**SUNDRY NOTICES AND REPORTS ON WELLS**  
*Do not use this form for proposals to drill or to re-enter an abandoned well. Use form 3160-3 (APD) for such proposals.*

1. Type of Well <input checked="" type="checkbox"/> Oil Well <input type="checkbox"/> Gas Well <input type="checkbox"/> Other		8. Well Name and No. ADELINE ALN FED 1
2. Name of Operator EOG Y RESOURCES INC Contact: KAY MADDOX E-Mail: kay_maddox@eogresources.com		9. API Well No. 30-015-20939-00-S1
3a. Address 104 S 4TH STREET ARTESIA, NM 88210	3b. Phone No. (include area code) Ph: 432-686-3658	10. Field and Pool or Exploratory Area S SAND DUNES
4. Location of Well (Footage, Sec., T., R., M., or Survey Description) Sec 6 T24S R31E SENW 1980FNL 1980FWL		11. County or Parish, State EDDY COUNTY, NM

EOG PROPOSES TO PLUG THIS WELL USING THE ATTACHED PROCEDURE. CURRENT AND PROPOSED WELLBORES ARE ALSO ATTACHED.

\*\* BLM REVISED \*\*

**Proposed Wellbore Diagram:**

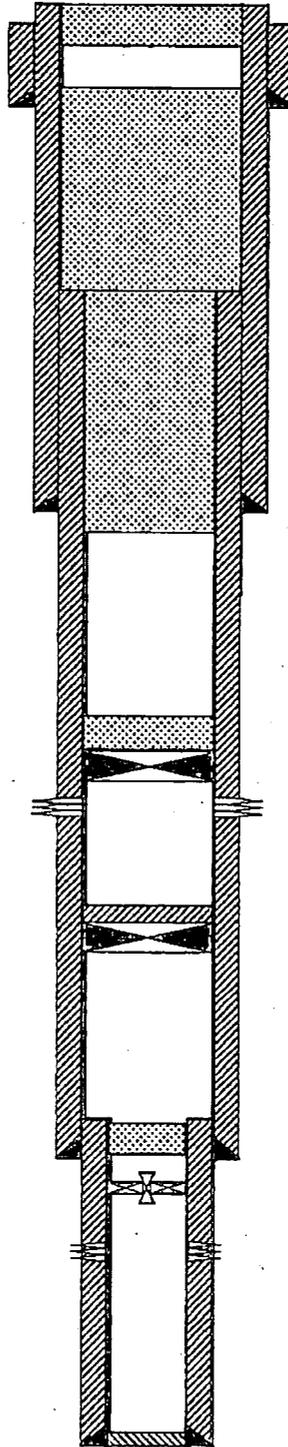
1. Notify Regulatory Agency 24 hours prior to commencing work. MIRU well service unit and all necessary safety equipment.
2. ND WH, NU BOP, release TAC at 6,795' and TOH laying down 2 7/8" production string.
3. Set 9.625" CIBP at 7,475'.
4. Tag CIBP, circulate plugging mud and spot ~~25~~ 170' plus 170' plus Class C on top of CIBP.
5. Pick up, spot a 2,030 sx class C cement plug from 4,200' – 425' due to R-111-P; WOC & tag.
6. Pick up, spot 70 sx class C cement from 100' to surface.
7. Cut off WH 3' below surface; Verify cement to surface.
8. Weld on P&A marker. Cut off anchors 3' below surface and clean location.
